**Project:** VCSD 2024 Capital Project

**Add. No.:** Pre-Bid Addendum 003

*A d d e n d u m*

**HEAT PUMP/CONDENSING UNIT  
DUNNAGE FRAMING PLAN**

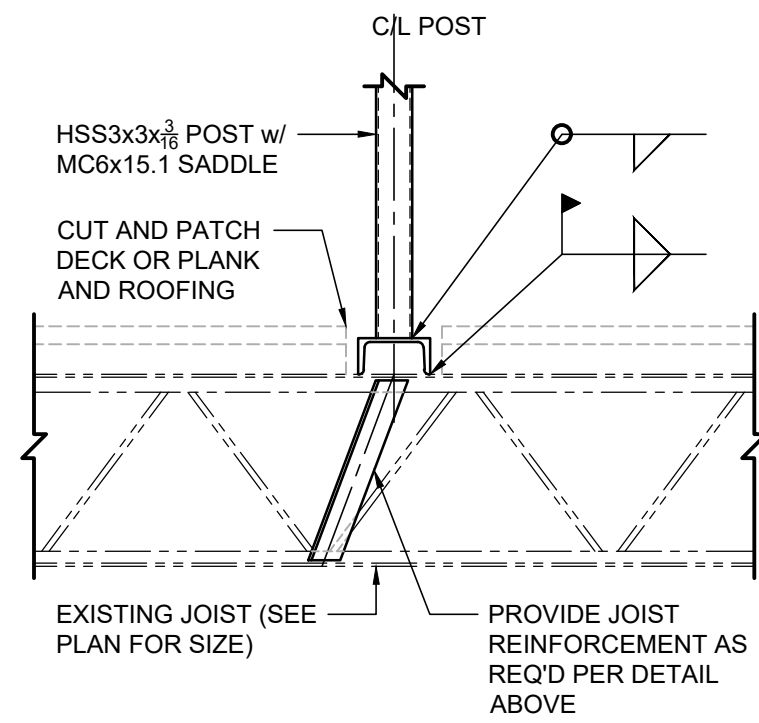
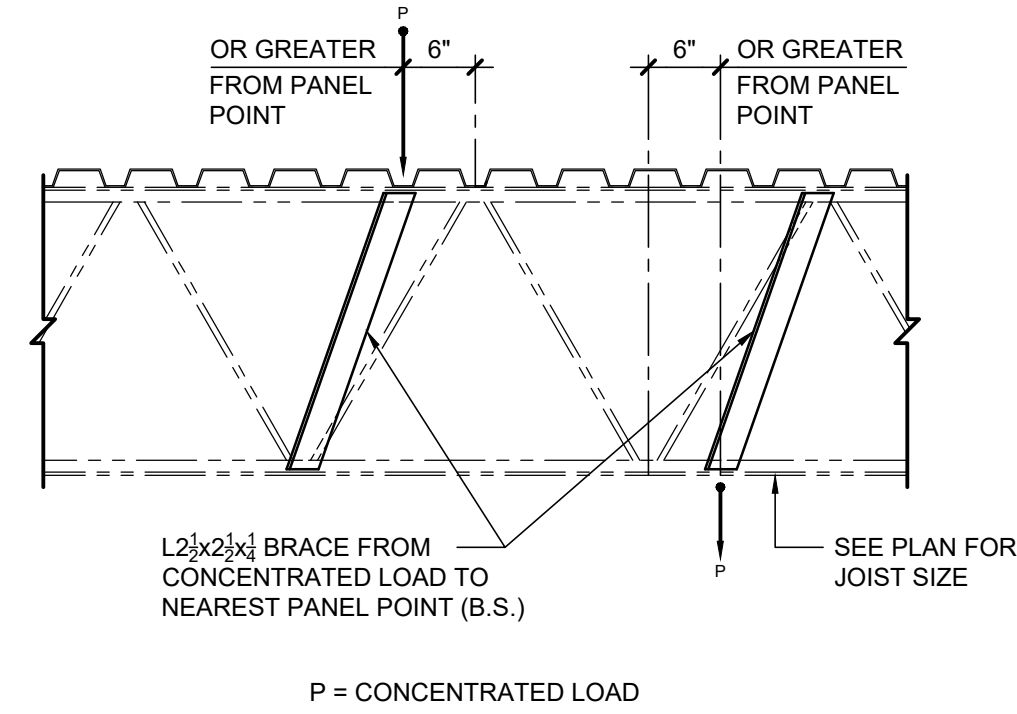
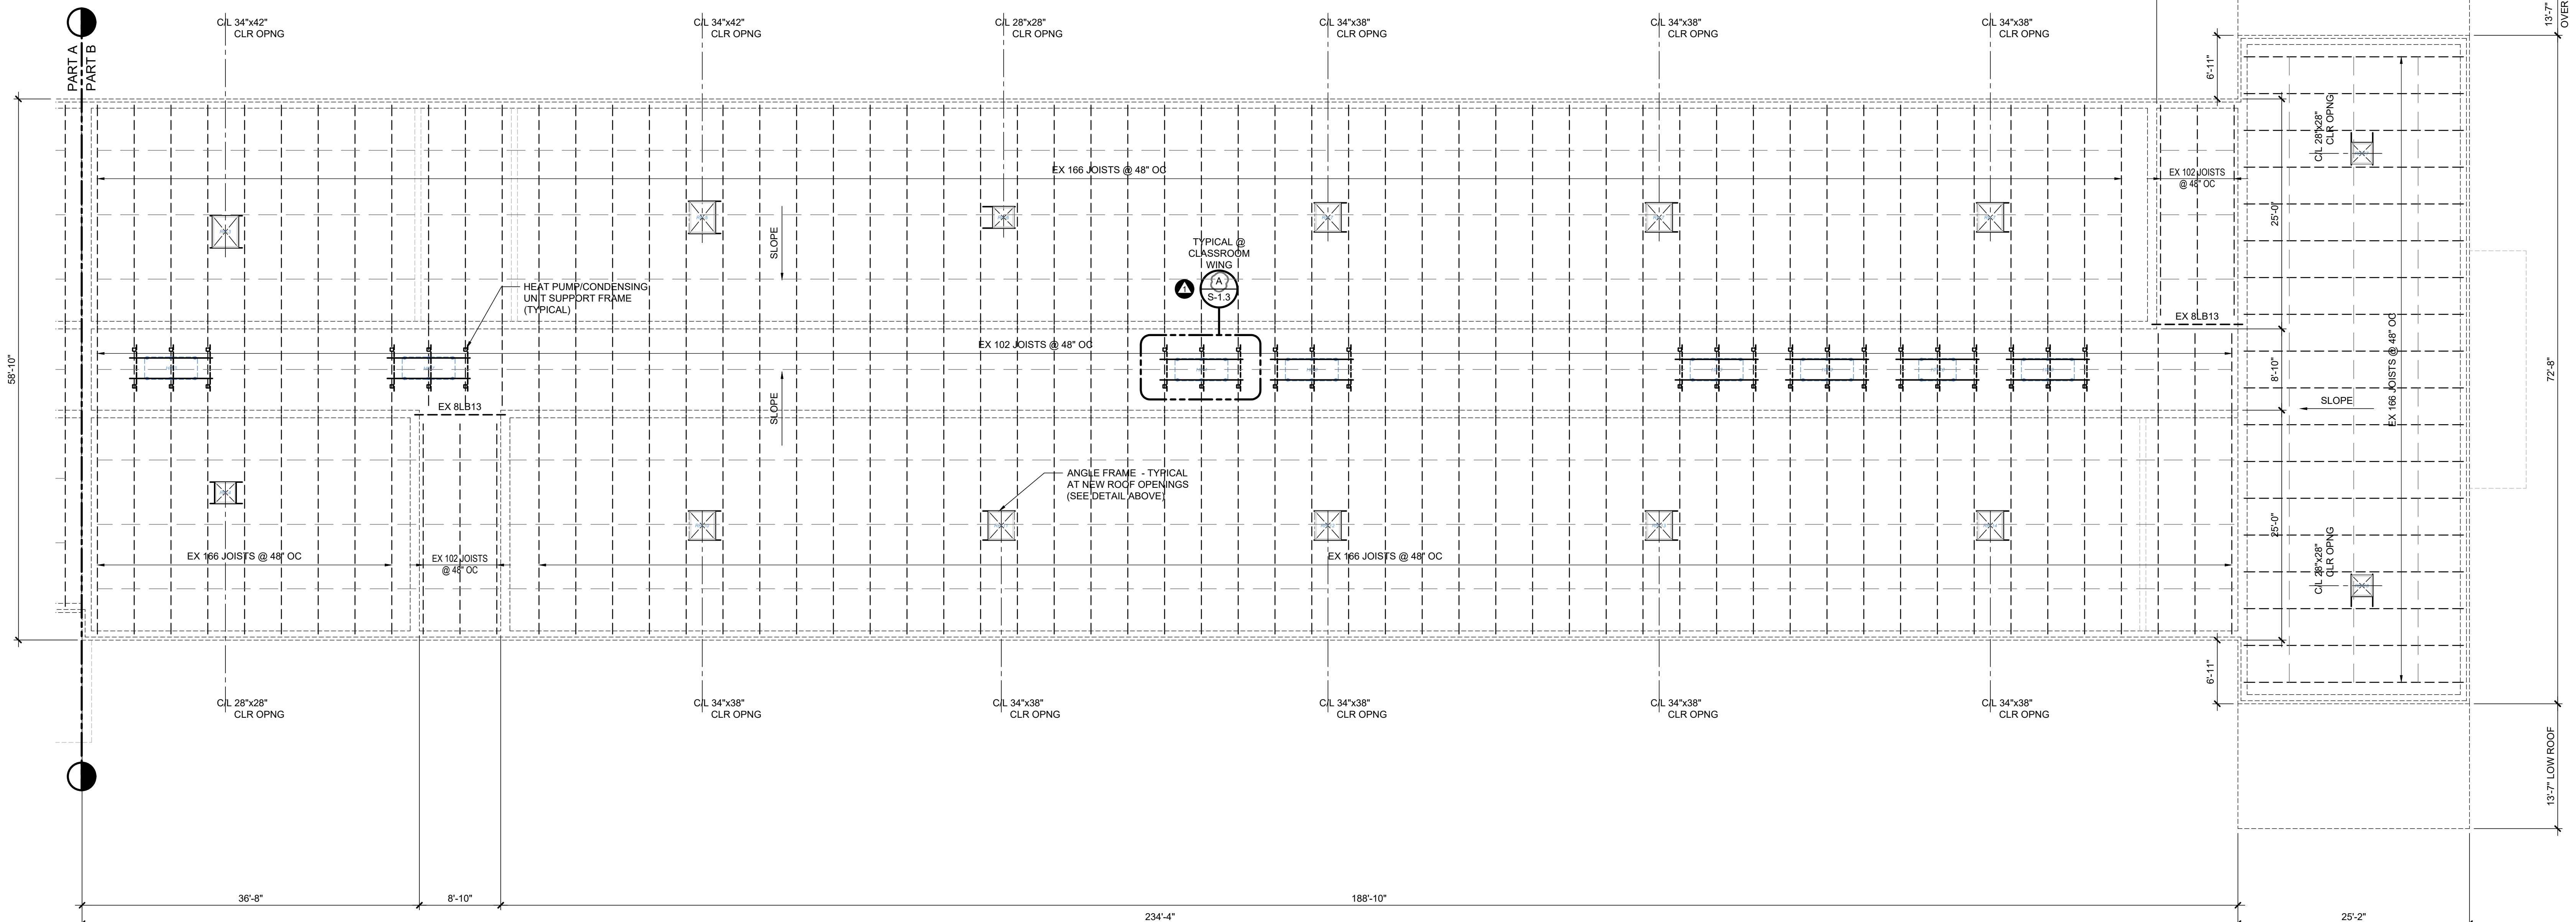
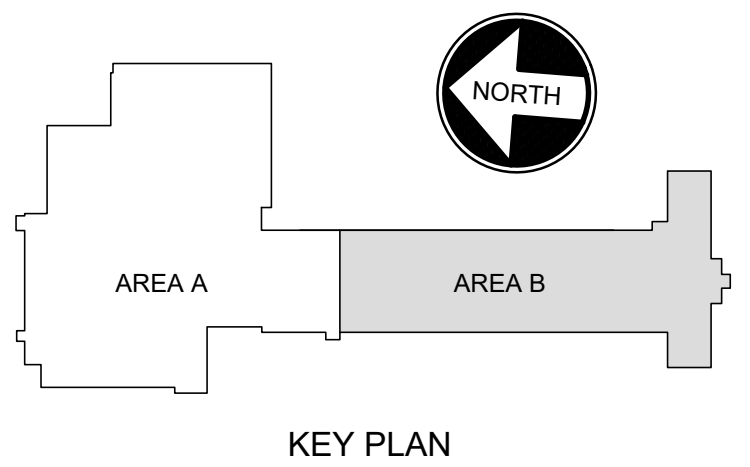
- DELETED DUNNAGE FRAMING PLAN B/S-1.3
- REVISED DUNNAGE REFERENCE FROM PLAN B/S-1.3 TO PLAN A/S-1.3
- DELETED SADDLE DETAIL FOR DUNNAGE POSTS ON WALL
